D7 V1.4 upgrading pack

This upgrading pack would make your V1.3, V1.2, V1.1 as much close to V1.4 as possible. Although it can not make your printer exactly the same to V1.4. It can improve your current printer at most.

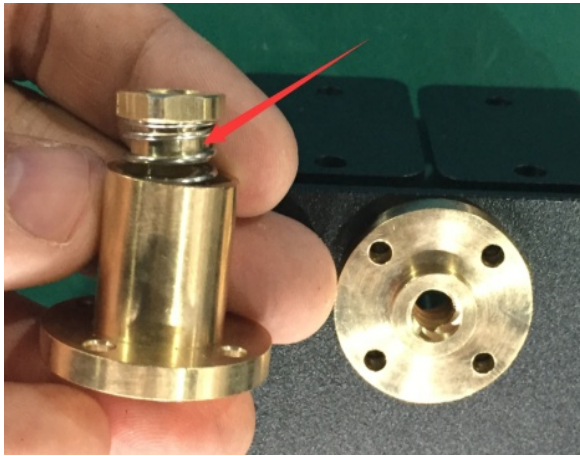
1		<p>Embrassing couple ensure the better concentricity.</p>
2		<p>The machining building plate with tolerance $\pm 0.03\text{mm}$ to ensure flatness. And Aluminum plate has good adhesive ability.</p>

**Anti-backlash Brass Z axis nut
to make Z axis movement
more precise.**
